| | | | | | | REFERENCE INFORMATION & FILE NO. OF SURVEYS |
|------|----------|------------|-----------------------------------|-------|-------|--|
| 1 | 10/28/20 | PCO#2 POLE | RELOCATION | KS/MA | MV/SL | |

| ALE: | 19TH AVENUE (STATE ROUTE 1) | CONTRACT NO 1000005 |
| 118 OF 356 | 19TH AVENUE AND KIRKHAM STREET | 111,4° REV. NO. |

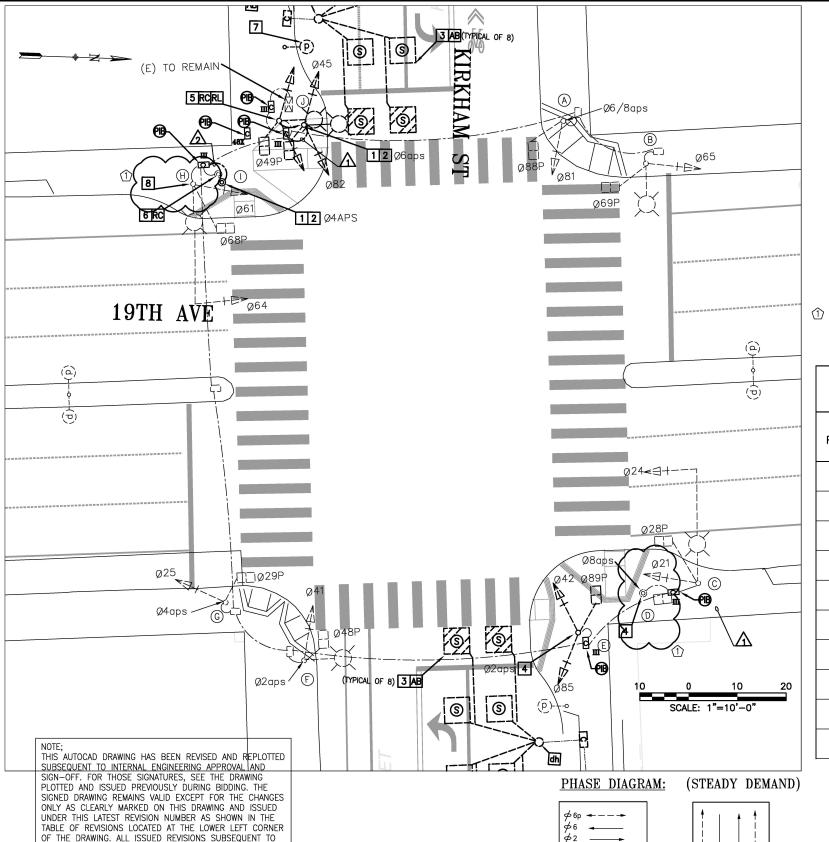
- [5] REMOVE AND RC EXISTING POLE, FOUNDATION, AND ASSOCIATED CONDUIT. RL EXISTING TRAFFIC SIGNALS, MOUNTINGS, STREET LIGHT FIXTURE TO POLE J.
- 6 REMOVE AND RC EXISTING POLE, FOUNDATION, AND ASSOCIATED CONDUIT.
